AINSTY (2008) INTERNAL DRAINAGE BOARD

Yorkshire GREEN – DC1

Q4.03 Ainsty Internal Drainage Board Response

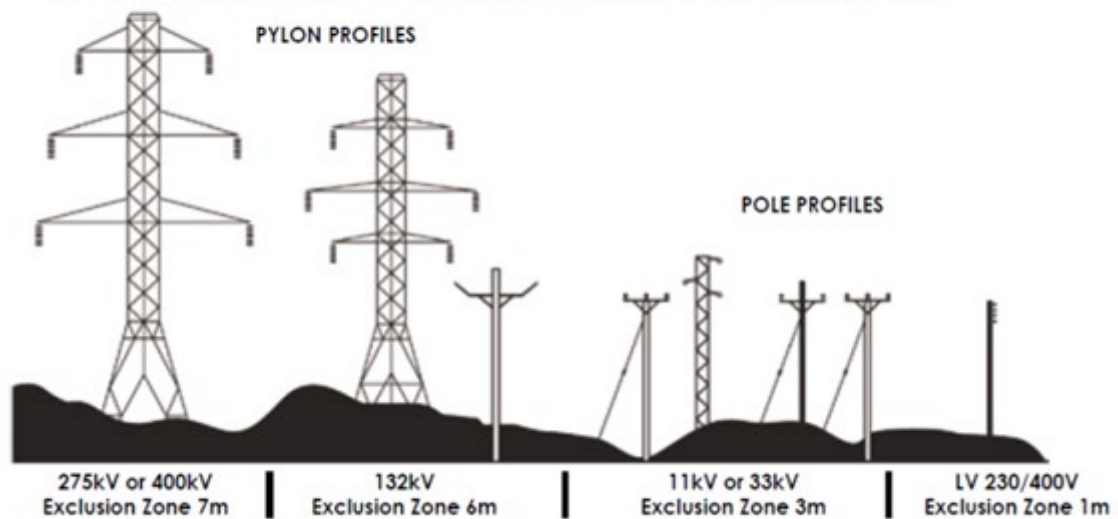
- You must not allow any part of your plant to enter the **EXCLUSION ZONE**.
- The diagram below shows typical types of overhead lines and provides a guide to help assess the line voltage of lines on wooden poles or steel pylons. The minimum **EXCLUSION ZONE DISTANCE** is shown for each example.

- Please note that these are absolute minimum distances that should under no circumstances be infringed. ***If you do - it could prove fatal.***

This clearly states that we should not be letting any part of our equipment in the “Exclusion Zone” and the “Exclusion Zone” for 275kV and 400kV is 7 metres.

The Boards equipment height is 3.5 metres.

This takes us to needing the overhead lines to be 10.5 metres above ground level.
